ADMINISTRATIVE AMENDMENT  
 FILE # 20038 PROJECT # 2015  
 Updated building elevations and architectural elements.  
 27 Sept 2019  
 APPROVED BY DATE

ADMINISTRATIVE AMENDMENT  
 FILE # 20038 PROJECT # 2015  
 Minor changes to:  
 parking and access,  
 landscape plan.  
 24 Feb 2020

ADMINISTRATIVE AMENDMENT

PROJECT TITLE: A MIXED USE DEVELOPMENT AT ALAMEDA AND SAN PEDRO NE ALBUQUERQUE, NM  
 PROJECT MANAGER: STEPHEN DUNBAR, AIA  
 JOB NO.:  
 DRAWN BY: CDC  
 SHEET TITLE: OVERALL SITE PLAN

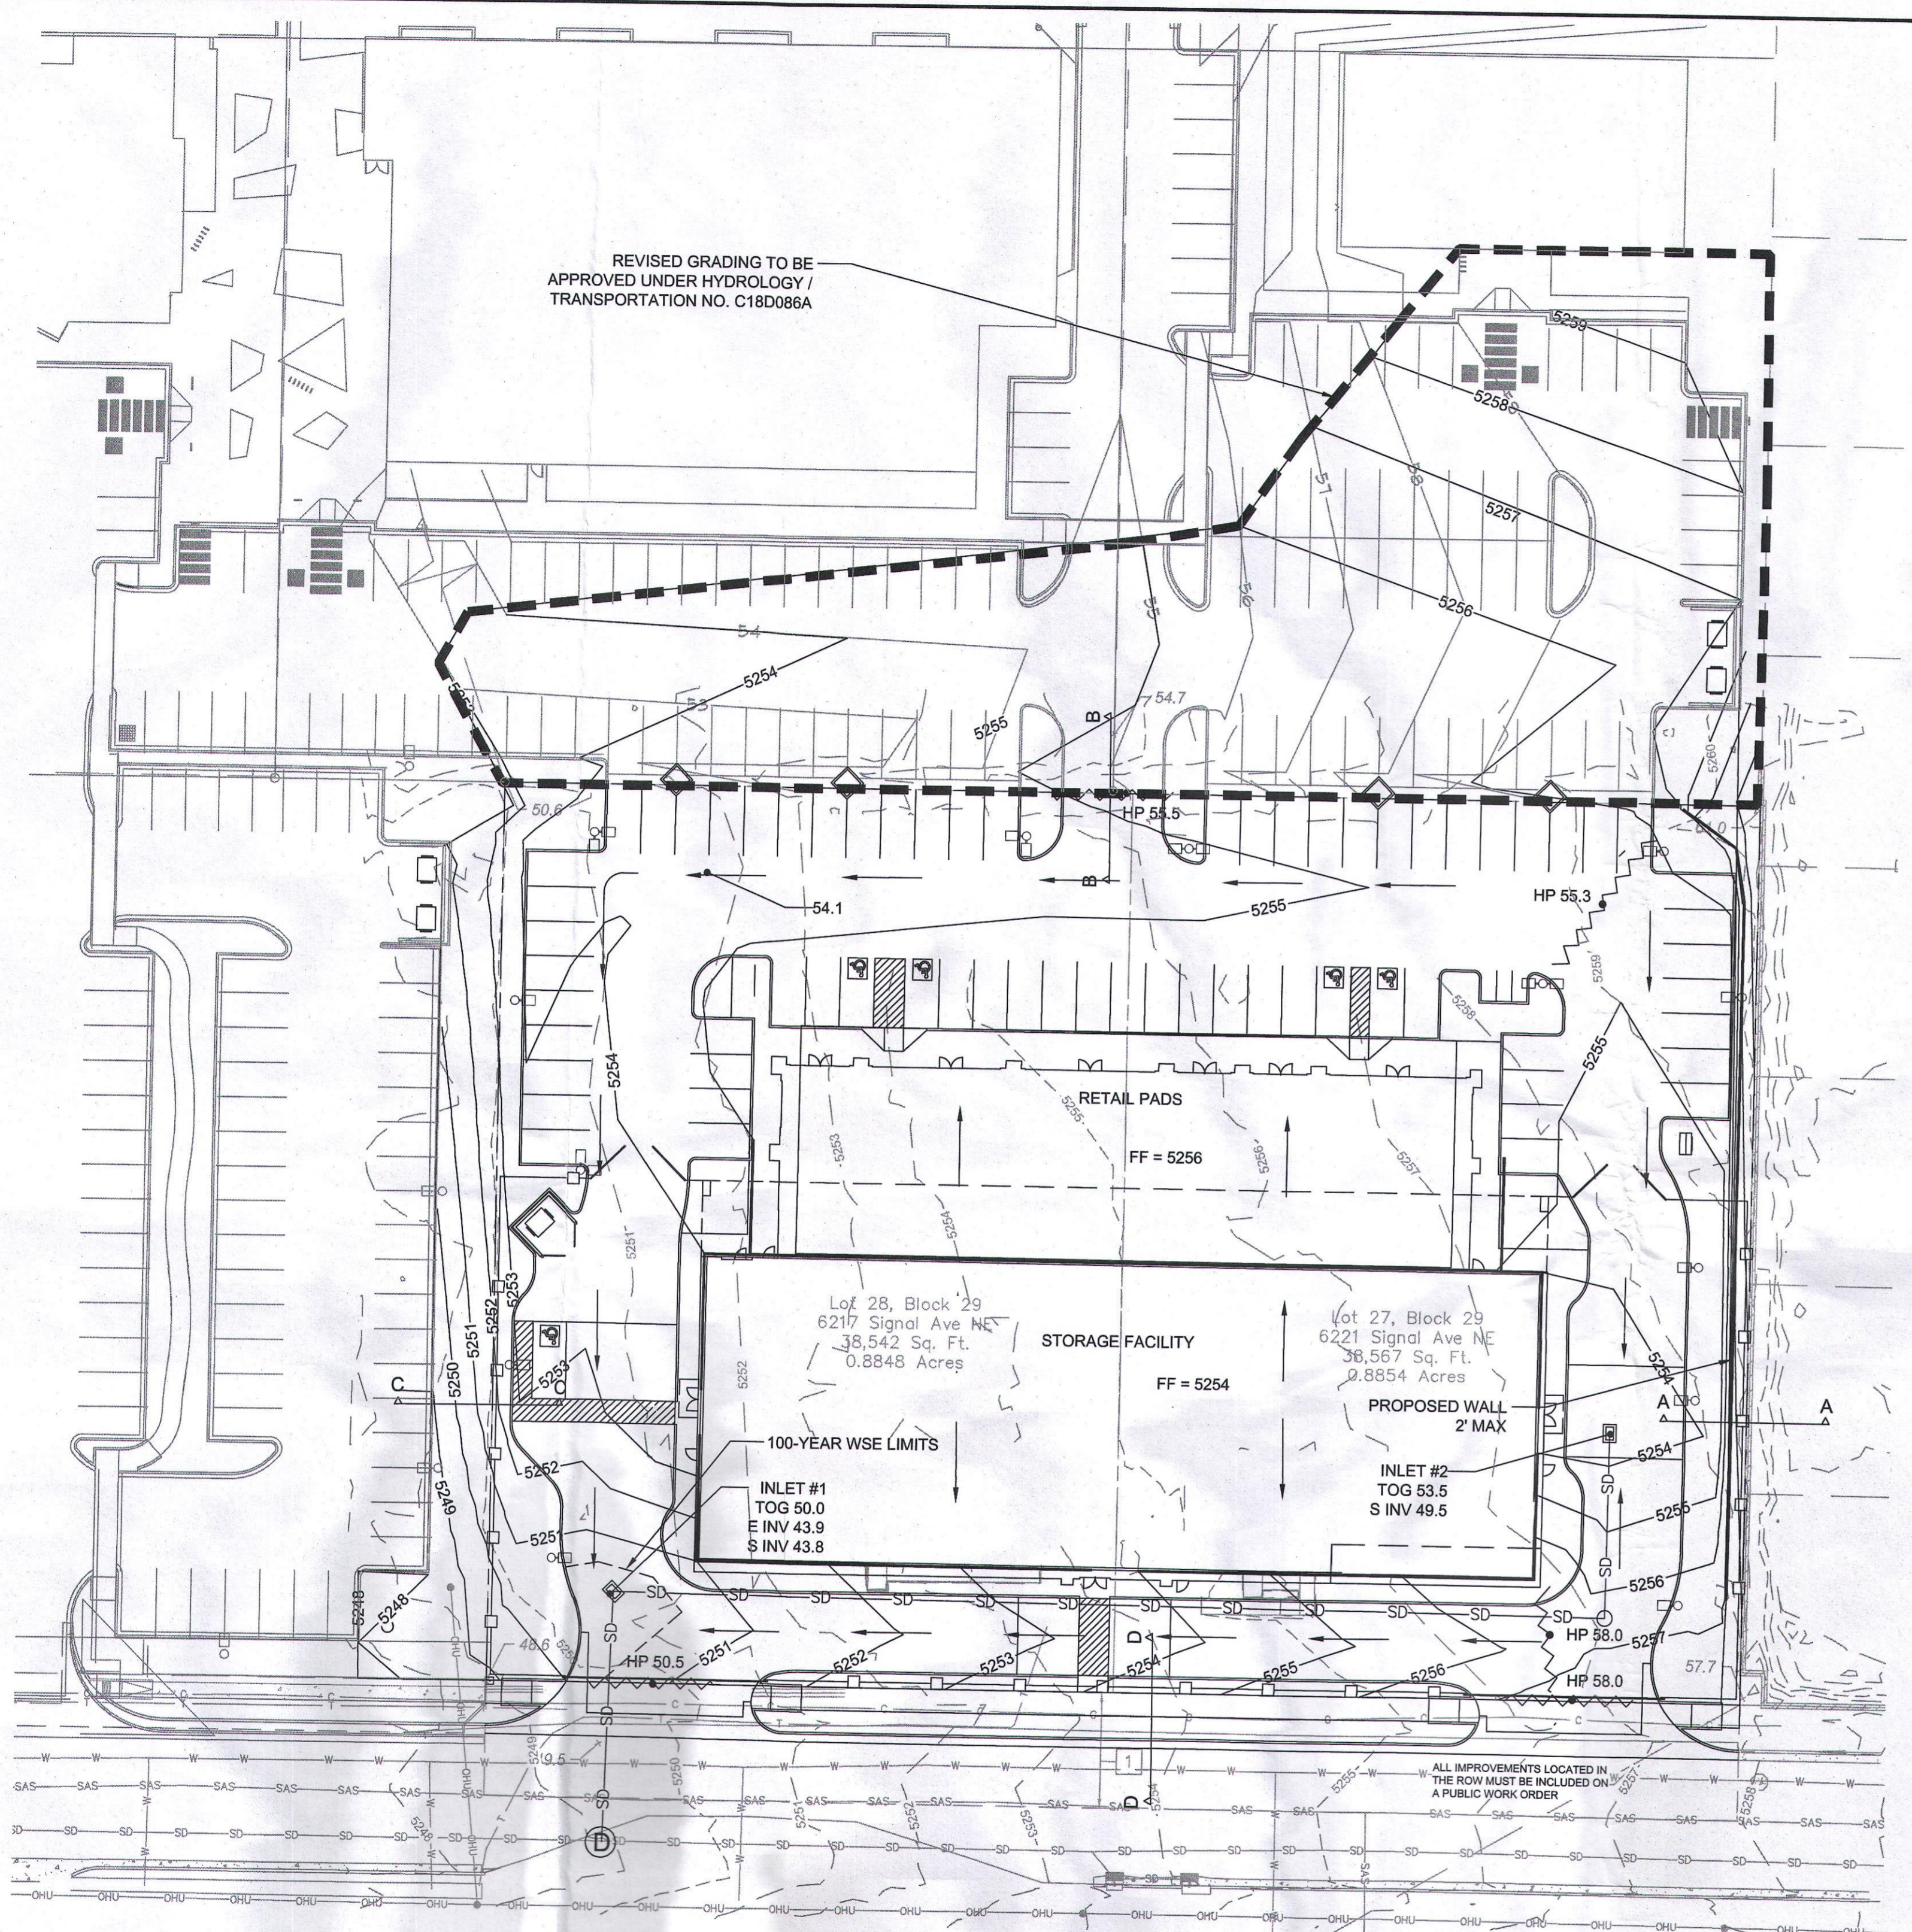
- GENERAL NOTES:**
1. NOT FOR CONSTRUCTION.
  2. ALL OTHER CONDITIONS OF THE PREVIOUSLY APPROVED GRADING PLAN APPLY. ONLY THE GRADING WITHIN THE LIMITS SHOWN HAS BEEN REVISED.
